CITY OF PATASKALA PLANNING & ZONING COMMISSION

STAFF REPORT

Planned Manufacturing Application PM-21-004

Applicant:	Trevor Extine
Owner:	Howard P. and Rosemary A. Emswiler, Trustees
Location:	0 Etna Parkway (PID 064-152862-00.000)
Acreage:	20.02 acres
Zoning:	PM – Planned Manufacturing
Request:	Requesting approval of a Planned Manufacturing application pursuant to Section 1253.07 of the Pataskala Code to allow for the construction of an office/warehouse facility for the property located at 0 Etna Parkway (PID 064-152862-00.000).

C107
Project No. 2021-259

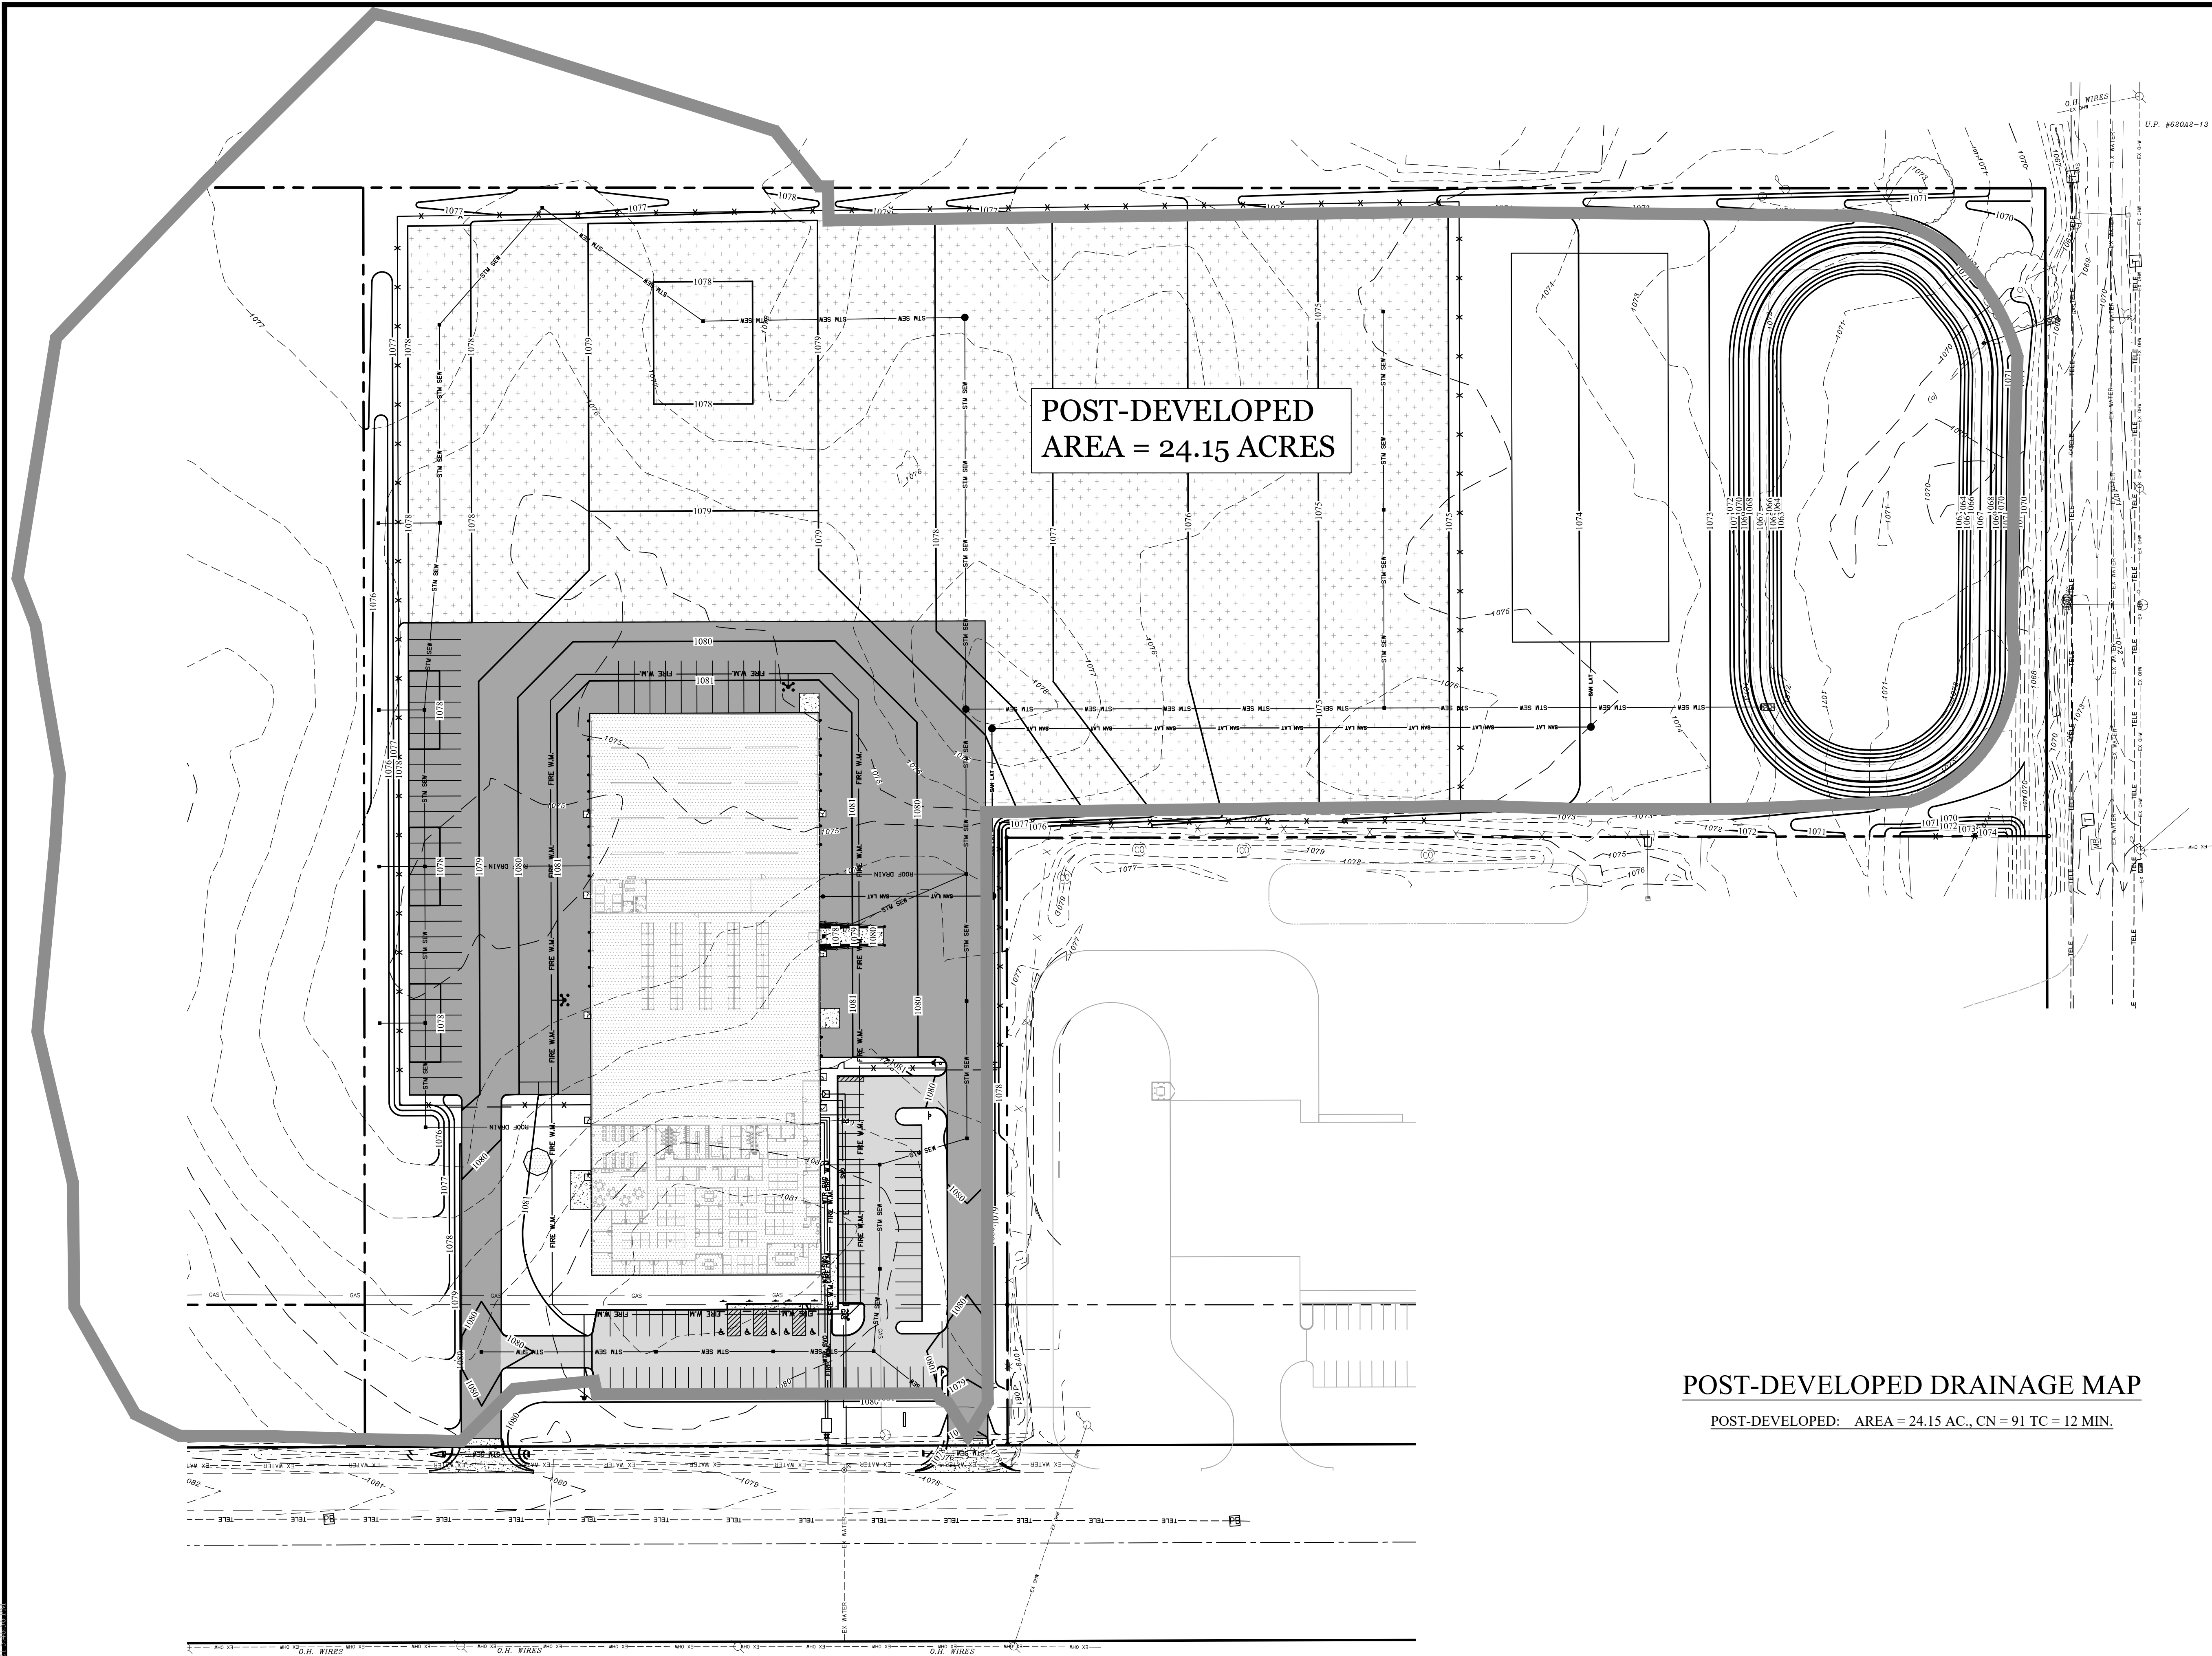
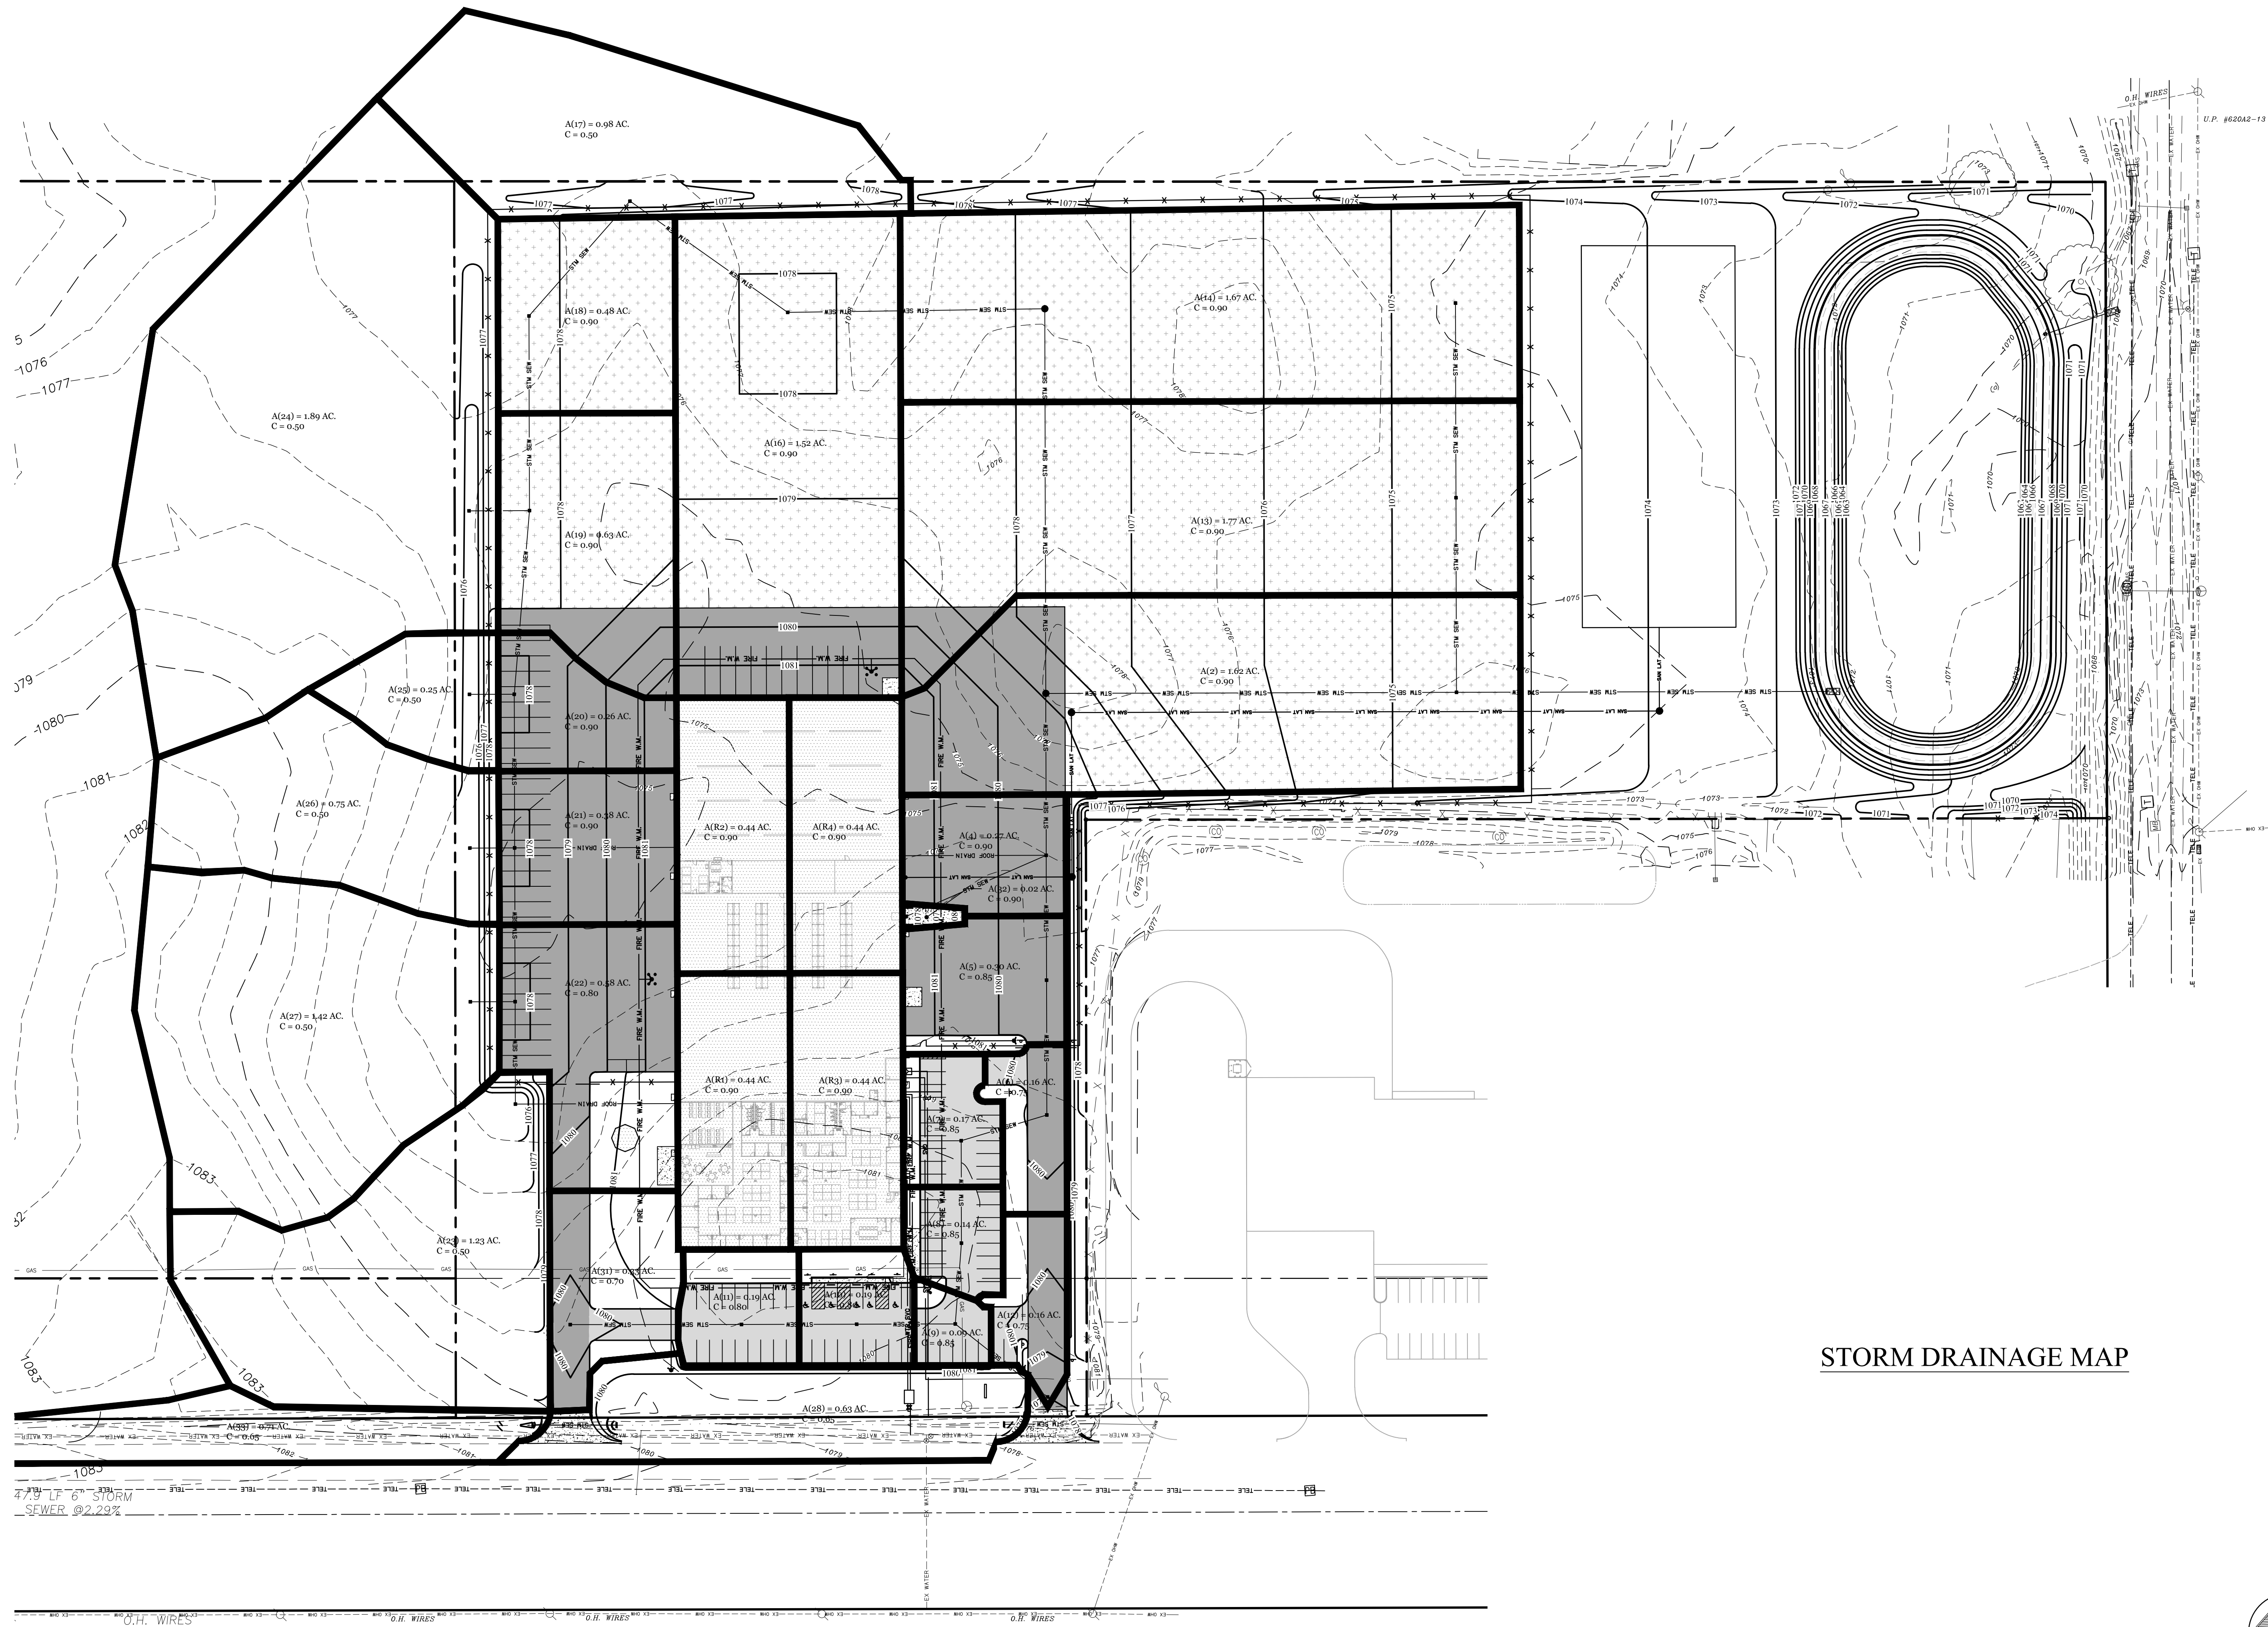
- Add "PM-21-004" to the title page.
- Apron on South Side access drive crosses approximately where property line is.
- Acreage on pages C107 and C107A indicates the acreage as 24.15-acres, which appears to be incorrect.
